NL-15-026

SUBJECT: Indian Point Energy Center's Fourth Six-Month Status Report for the Implementation of Order EA-12-051 Modifying Licenses with Regard to Requirements for Reliable Spent Fuel Pool Instrumentation (TAC Nos. MF0737 and MF0738)
Indian Point Unit Numbers 2 and 3
Docket Nos. 50-247 and 50-286
License Nos. DPR-26 and DPR-64

ATTACHMENT TO NL-15-026

Indian Point Energy Center's (IPEC) Fourth Six Month Status Report for the Implementation of Order EA-12-051 Modifying Licenses with Regard to Requirements for Reliable Spent Fuel Pool Instrumentation

Figure 1: Unit 2 SFP Elevation View with Levels Indicated

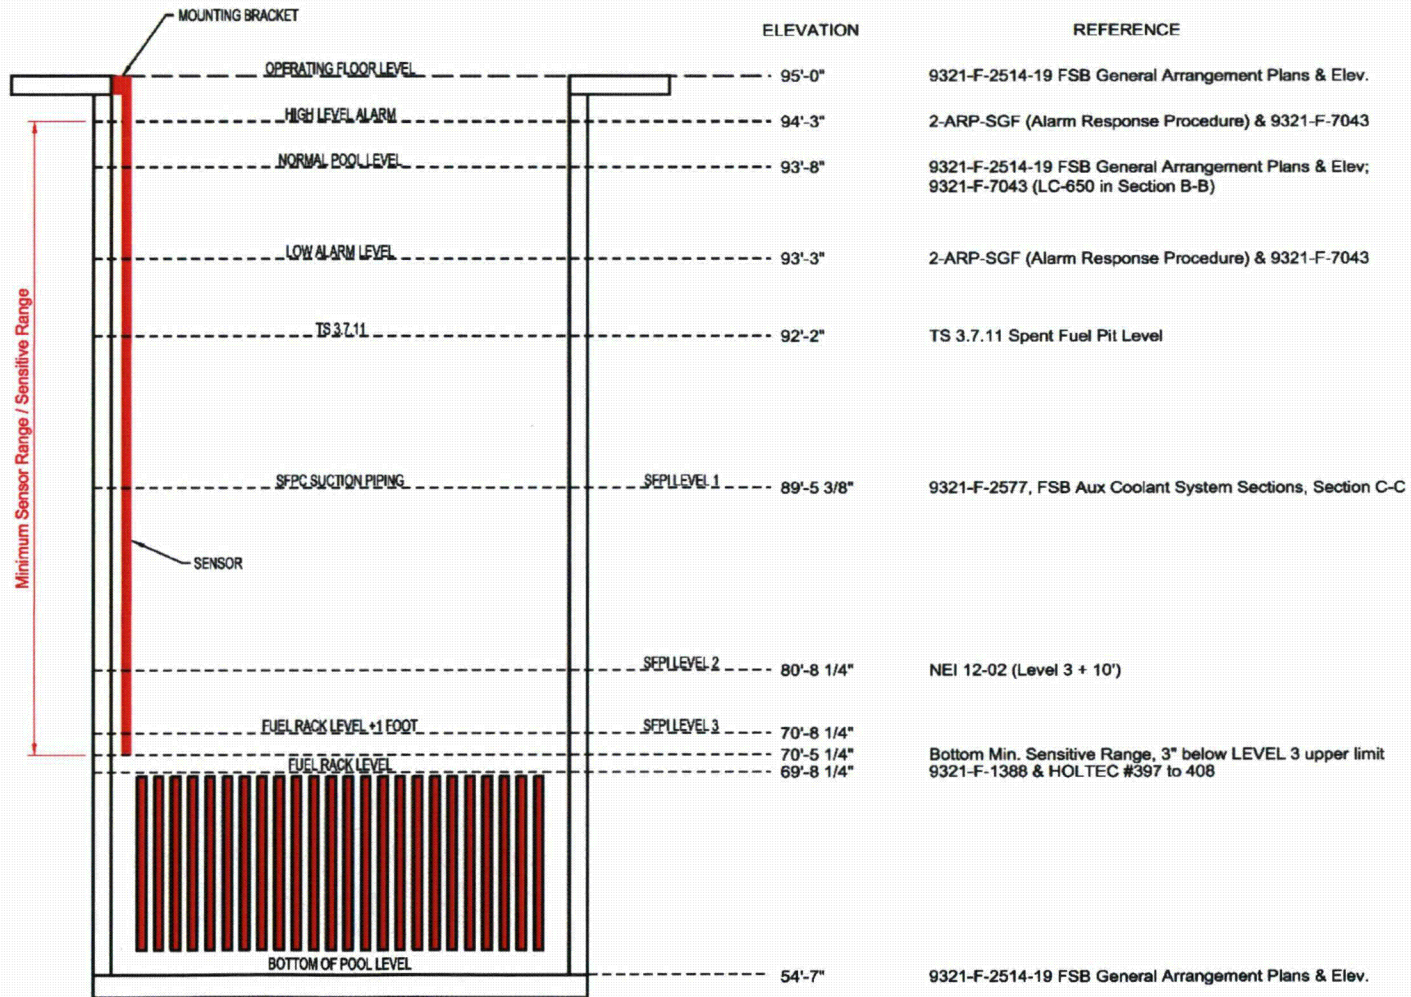
Please provide a final configurations of the IP2 and IP3 SFP area, clearly depicting the SFP monitoring Level 1, 2, and 3, the planned locations/placement of the primary and back-up SFP level sensor/probe, and the proposed routing of the cables that will extend from the sensors toward the location of the read-out/display device.

Figure 1 & Figure 2 depict an elevation view of the Unit 2 & Unit 3 final SFP Monitoring Levels.
